No. 618C

December 17, 1974

Replaces No. 618, 618A and 618B

KICK STARTER GEAR / XL, XLH, XLCH

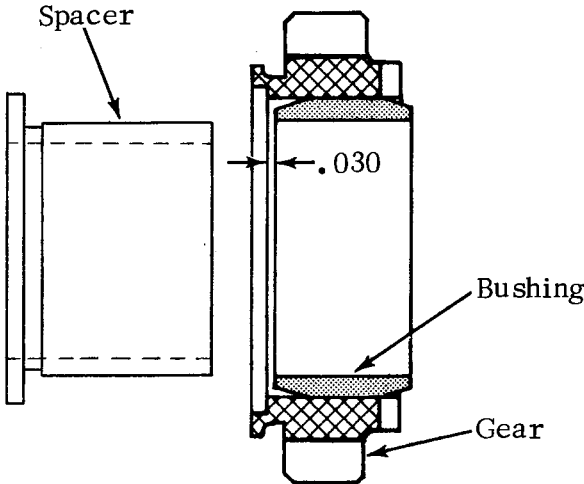
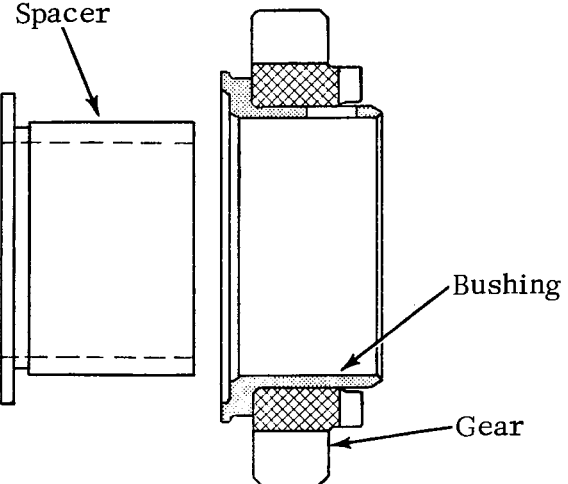
Motorcycles manufactured after July 1, 1973 incorporate new design kick starter gear, bushing and spacer. The new pressed-in bushing features a Teflon coated lead bearing surface on a steel shell. The gear itself incorporates the groove for the starter spring. The spacer length and diameter have been increased to fit the new gear. See illustration of new and old gears.

New parts, as an assembly only, are recommended for old part replacement on all models built before July 1, 1973. New parts cannot be interchanged with old parts individually - they must be used together.

Kits are available for old part replacement under part No. 33400-74 for 1970 & earlier, and part No. 33460-74 for 1971 & later.

Kit 33400-74 includes a starter ratchet part No. 33379-57 and twelve rivets part No. 8215. This ratchet has a larger I.D. for larger O.D. new gear bushing. Remove old ratchet from clutch sprocket and replace with new ratchet in kit.

In each engine, after old parts are replaced with new parts in kit, new parts as listed can be used individually for future replacement (See Following Table).
